Access Compliance Report

Public Rights-of-Way

| Intersection ID: 43988 | Main Street: N_HOSKINS_RD | Cross Street: TUCKERS_GLEN_LN | Location: N |
| ADA ID: 3D7B901BA027 | Ramp Type: PerpDiag | Initial Pass/Fail: Fail | Overall Compliance: No |

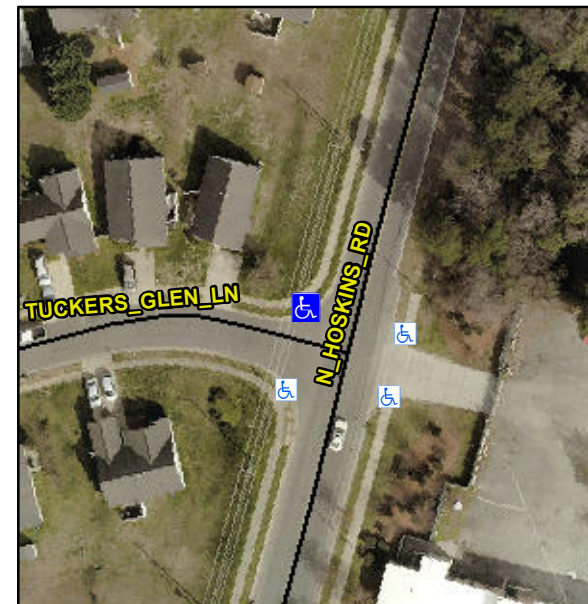
R304.5.1, R304.2.2

| Compliance | Description | Data | Compliance | Description | Data |
|------------|-----------------------|-------|------------|-----------------------------|-------|
| N/A | Ramp Length (in) | 84.5 | No | Ramp Slope (%) | 8.6 |
| No | Ramp Width (in) | 36.5 | Yes | Ramp XSlope (%) | 1.2 |

Remove & Replace Curb Ramp With Two New Directional Ramps or Equivalent.
